**Squeaks & Rattles – Noise from  
PAS Reservoir – Adjust Mounting**

MODEL 1995 MY  
Sedan Range  
VIN 720001-740691

ILLUSTRATION 1

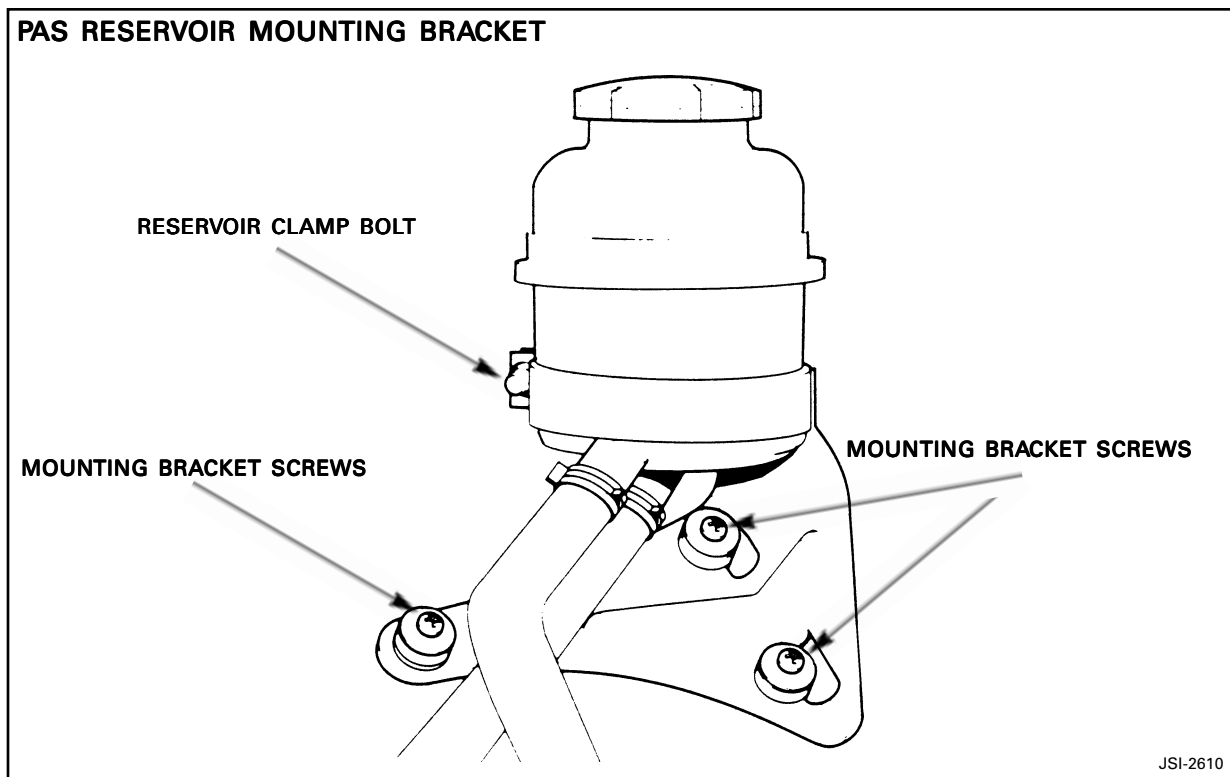
Some 1995 MY Sedan Range vehicles within the above VIN range may exhibit a noise from the right side of the fascia/bulkhead/underhood area.

The noise can be caused by contact between the cap of the power assisted steering (PAS) fluid reservoir and the hood insulating lining.

The reservoir location was modified starting with VIN 740692.

1. Remove the toolbox assembly.
2. Loosen the clamp bolt (Illustration 1) that retains the PAS reservoir in the mounting bracket.

3. Raise the reservoir to allow access to the screws (Illustration 1) that secure the bracket to the inner fender well.
4. Loosen the mounting bracket screws.
5. Push the mounting bracket down as far as it will go. Tighten the screws while holding the mounting bracket down as far as possible.
6. Push the reservoir down into the mounting bracket and tighten the clamp bolt. The reservoir should now be seated as low as possible in the mounting bracket.
7. Reinstall the toolbox assembly.
